FINAL DRAINAGE REPORT

FALCON RANCHETTES FILING NO. 1A
MERIDIAN STORAGE
El Paso County, Colorado

PCD File No. VR239 & PPR2336

October 20, 2023

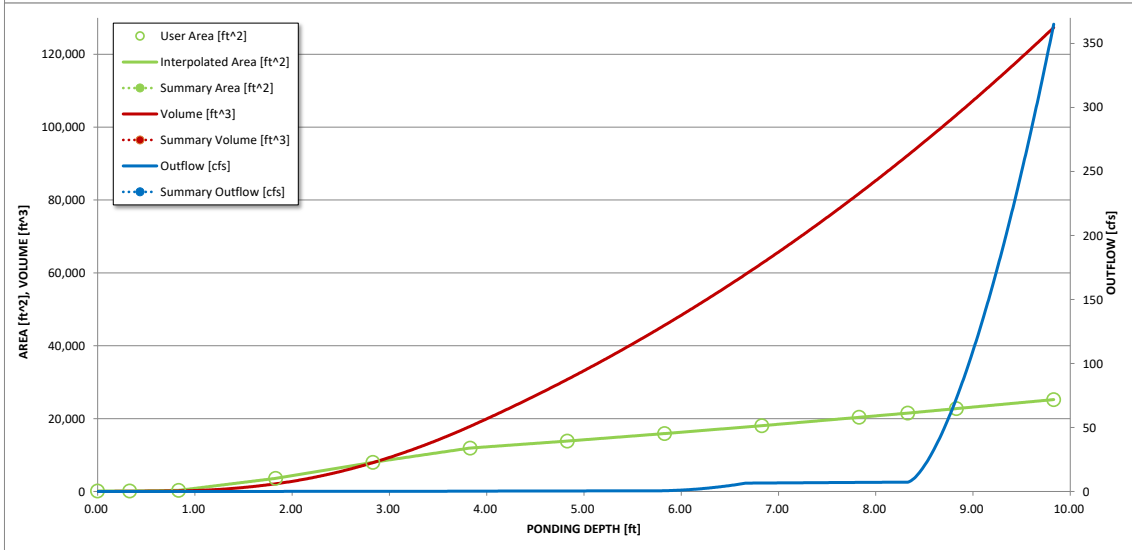
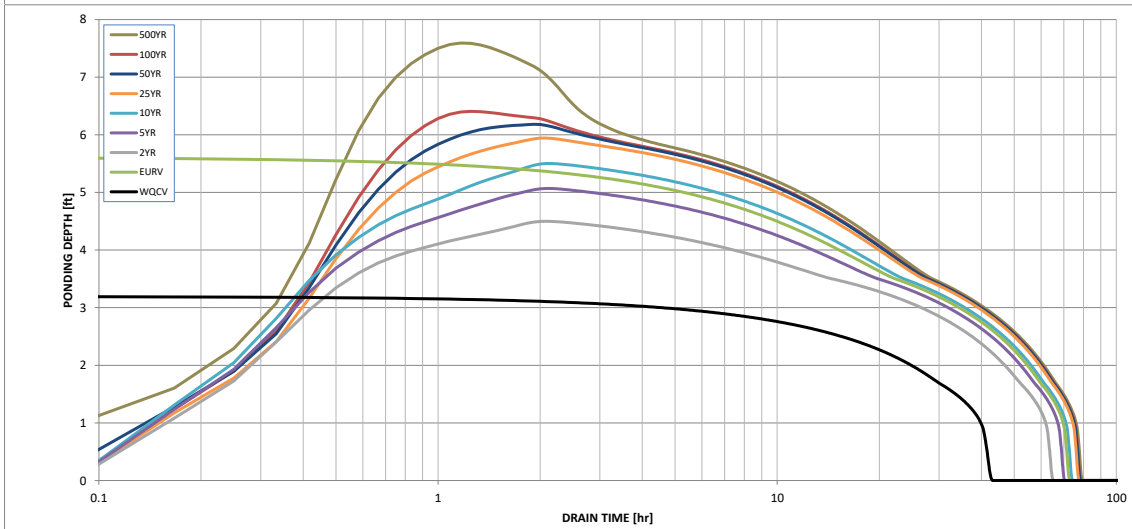
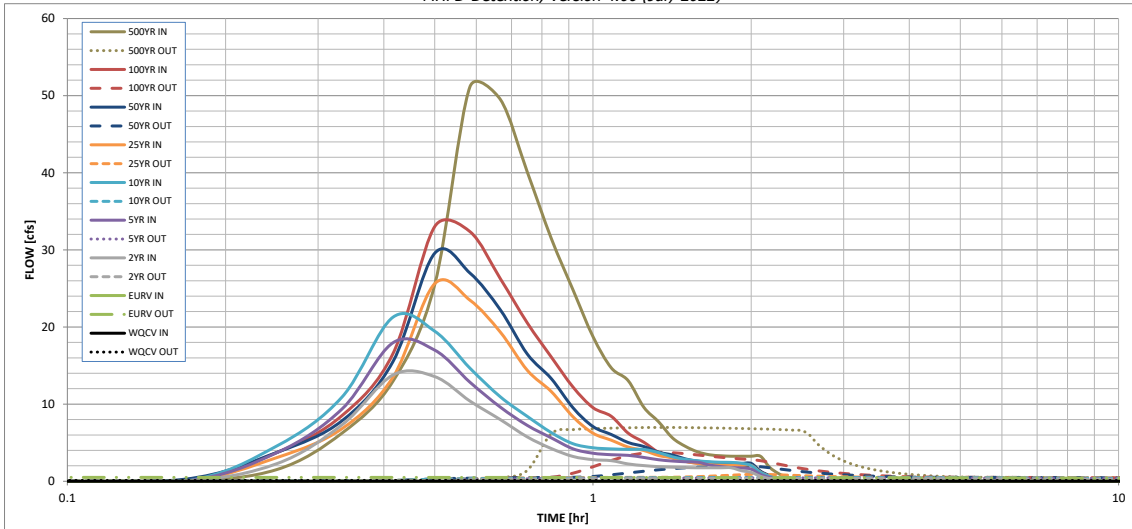
Verify and update so the ratios are not above 1

CANNOT GET CLOSE TO 1.00 WITHOUT EXCEEDING A 72 HOUR DRAIN TIME FOR THE 5-YEAR STORM TO MEET COLORAD REVISED STATUTE 37-92-602 (8)

FURTHERMORE, THE DIFFERENCE IN FLOW IS 0.2 CFS AND SHOULD BE CONSIDERED A NOMINAL INCREASE
